## Instruction Sheet

**Subject: Software Update, Sediment Tray Removal, Basket Support Rack Installation and OIB plug Inspection Instructions**

**Models affected: Taco Bell FilterQuick Touch Gas Fryers (FQG30-T)**

Figure 2

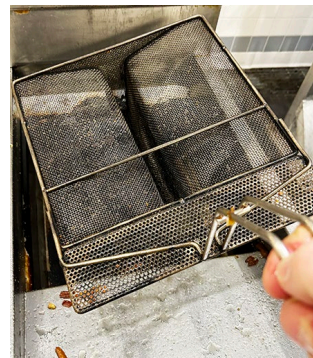
1. Remove the sediment tray from both frypots (see Figure 2).
2. Remove the sediment trays from the store and discard. **DO NOT LEAVE THE SEDIMENT TRAYS AT THE STORE!**

Figure 3

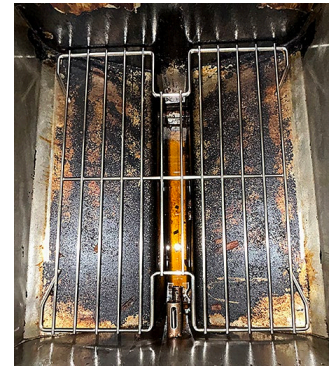
Install the new basket support racks in both frypots as shown (see Figure 3)

Figure 5

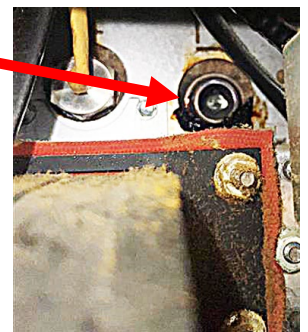
1. Open the doors of the fryer and locate the blower (see Figure 4).
2. Locate the OIB plug directly above and to the right of the blower (see Figure 5). The OIB plug is a 3/8" square socket plug.
3. Take five (5) photos.
  - a. Photo of Sediment Tray removed (see Figure 2).
  - b. Photo of wide shot showing blower and drain area (see Figure 4).

Figure C

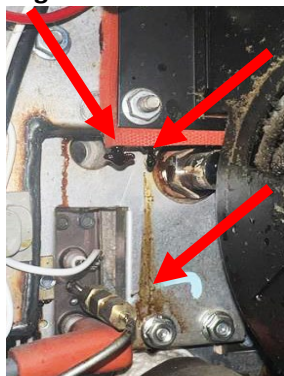
7. Plugs resembling Figure B that have oil around the OIB plug and Figure C with oil around the ignitors should use a ratchet wrench with 15" of extensions, with a 3/8" square tapered wobble head, to rotate the plug clockwise and torque to 54 ft lbs. to ensure it is seated tight in the frypot and not leak (see Figures 8 and 9 above). If it can be determined that oil has entered the insulation, make a note and schedule a second trip to replace the insulation with kit 8263805. Advise the customer they will be responsible for the cost of the repair.

Figure E

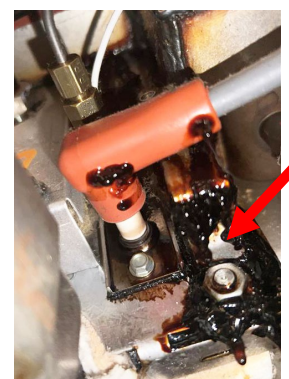
8. Plugs resembling Figure D that have an excess of oil around the OIB plug and in Figure E that shows excessive oil on the ignitors, should knock any oil out of the plug and use a ratchet wrench with 15" of

insulation with kit 8263805. Advise the customer they will be responsible for the cost of repair.
